To All Bidders of F-23-NQ-01:

Please note: the following addendum applies to F-23-NQ-01 and shall be taken into consideration when preparing bid documents.

Addendum #3
Upgrade of Neqotkuk Wastewater Treatment Facility
Project Number F-23-NQ-01

Drawing C08:

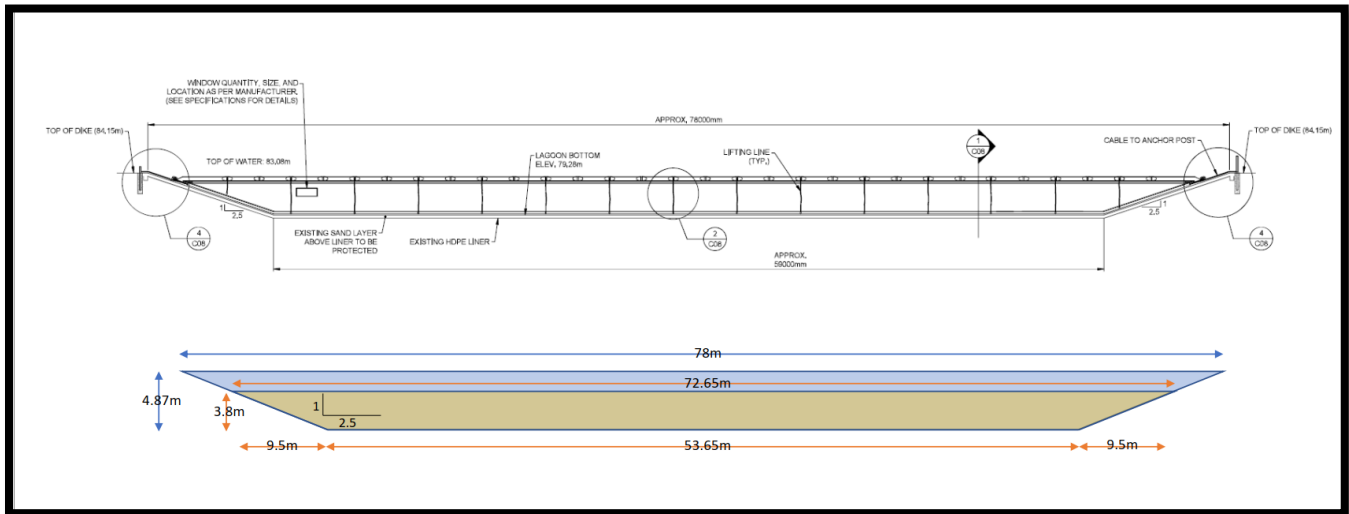
Question: For the floating Baffle Curtain wall, Drawing C08 shows 78m at top of slope & 59m at toe of slope. If we use 78m at top of slope & 2.5/1 slopes & 4.87m high, the bottom dimensions should be closer to 53.65m & 72.65m at water level. See attached PDF showing the measurements. Or if the 78m is at water level, then the 59m at the bottom of slope would be correct. Can you confirm Baffle dimensions?

Answer: The top water elevation (of 83.08 m) and bottom elevation (of 79.28 m) are correct. The top width is approximately 78.0 m. Please revise the bottom width to 45.0 m and update the side slopes to 3H:1V.
